Re: Petition No. 1651 – responses to first set of interrogatories

PETITION OF FAIRY LAKE, LLC	:	PETITION NO. 1651
FOR A DECLARATORY RULING THAT	:	
A CERTIFICATE OF ENVIRONMENTAL	:	
COMPATIBILITY AND PUBLIC NEED	:	
IS NOT REQUIRED A 4.99-MEGAWATT	:	
AC BATTERY ENERGY STORAGE	:	
FACILITY AT 380 NEW LONDON	:	
ROAD, SALEM, CONNECTICUT	:	February 26, 2025

**PETITIONER’S RESPONSES TO THE FIRST SET OF
INTERROGATORIES BY THE CONNECTICUT SITING COUNCIL**

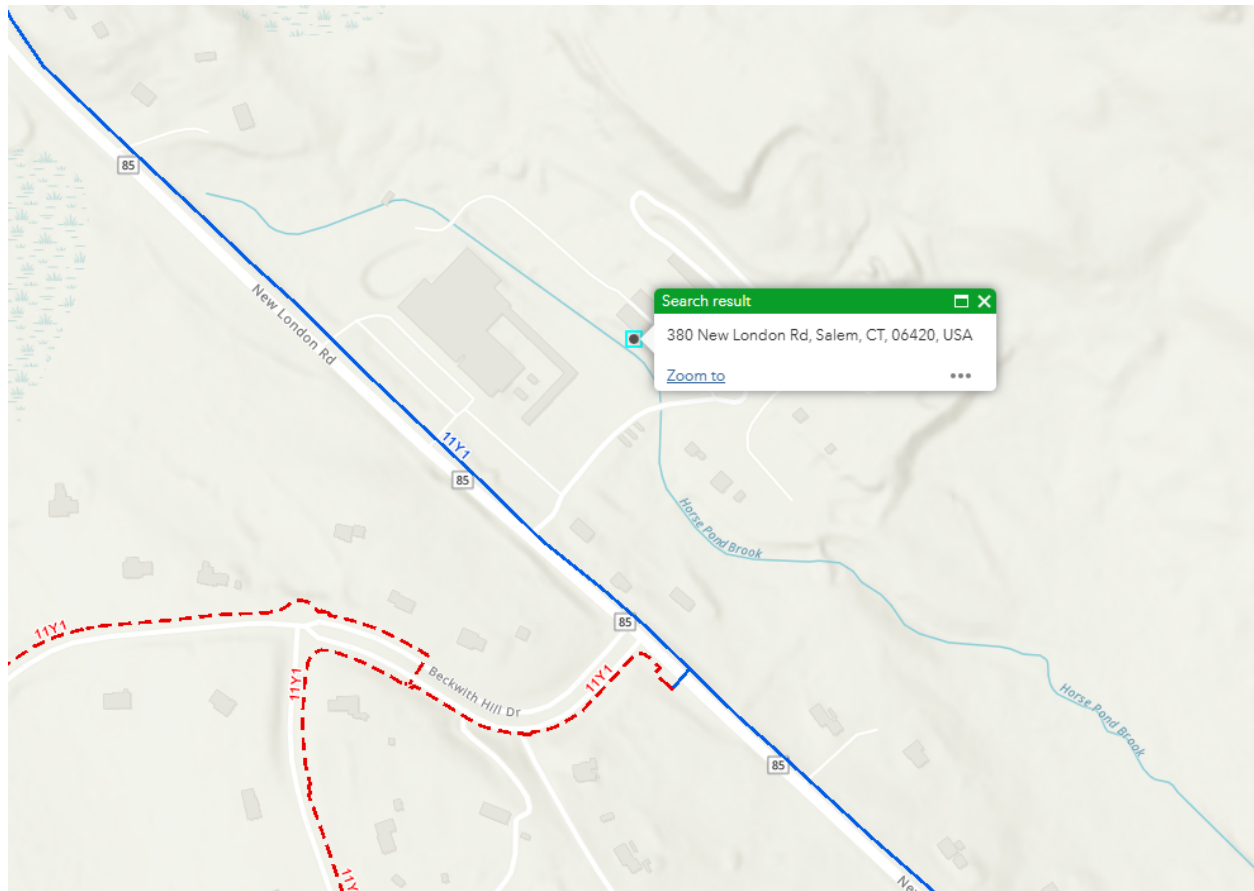
20. What are the benefits of the proposed site location? For example, is the proposed site located within a “load pocket” area or on the “grid edge”?

RESPONSE: This project is located on a “grid edge” circuit as evidenced by the screenshot below from Eversource’s Grid Edge map from the Energy Storage Solutions program.³ The Energy Storage Solutions program provides priority to projects located on the “grid edge” that experience higher than usual disruptions to electric service. Thus, the project’s location has the potential to deliver resilience benefits to an area that has historically experienced power quality challenges.
